DAVE BAXTER
Vice President
Oconee Nuclear Station

Subject: Duke Energy Carolinas, LLC
Oconee Nuclear Station, Unit 2
Docket Nos. 50-270
Third Ten Year Inservice Inspection Interval
Request for Relief No. 04-ON-009, Revision 1
Request for Additional Information Response

DUKE ENERGY CORPORATION
RESPONSE TO NRC REQUEST FOR ADDITIONAL INFORMATION (NRC
LETTER DATED MAY 22, 2008 - FOUR ITEMS)
3RD 10-YEAR INSERVICE INSPECTION INTERVAL

2-1 DCB-INLET-V1

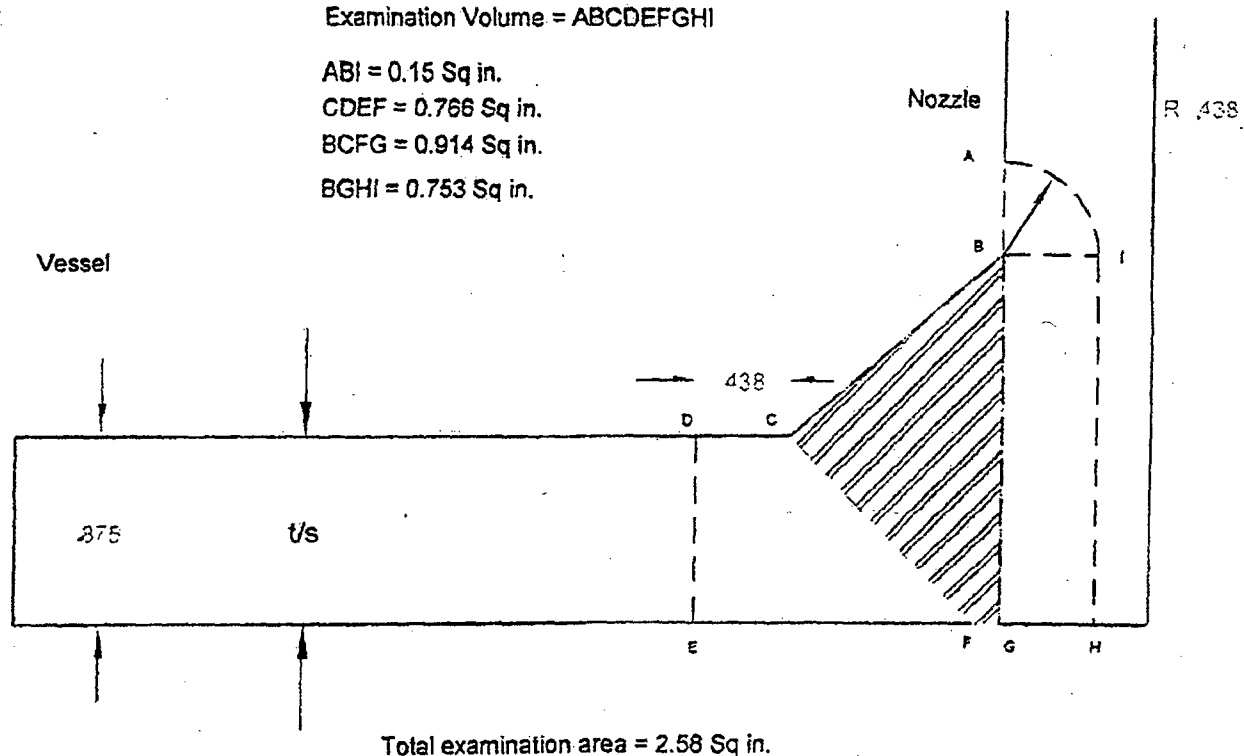
4. For welds 2-LDCB-INLET-V1 and 2-LDCB-OUTLET-V2, RR 04-ON-009 states that the Examination Volume is A-B-C-D-E-F-G-H-I-J. However, in Figure IWB-2500-7(a), the examination volume A-B-C-D-E-F-G-H-I is provided. Please correct this inconsistency.

For welds 2-LDCB-INLET-V1 and 2-LDCB-OUTLET-V2, examination data sheets defined the examination volumes as A-B-C-D-E-F-G-H-I-J in accordance with interpretation of the nozzle configuration of the letdown coolers. Review of the Duke component and weld isometric drawings show that the examination volume defined as A-B-C-D-E-F-G-H-I in Figure IWB-2500-7(a) accurately represents the examination volume of welds 2-LDCB-INLET-V1 and 2-LDCB-OUTLET-V2. Recalculation of coverage using the examination volume of Figure IWB-2500-7(a) shows an aggregate coverage of 29.4% for each weld 2-LDCB-INLET-V1 and 2-LDCB-OUTLET-V2.

Examination Volume = ABCDEFGHI

Total examination area = 2.58 Sq in.
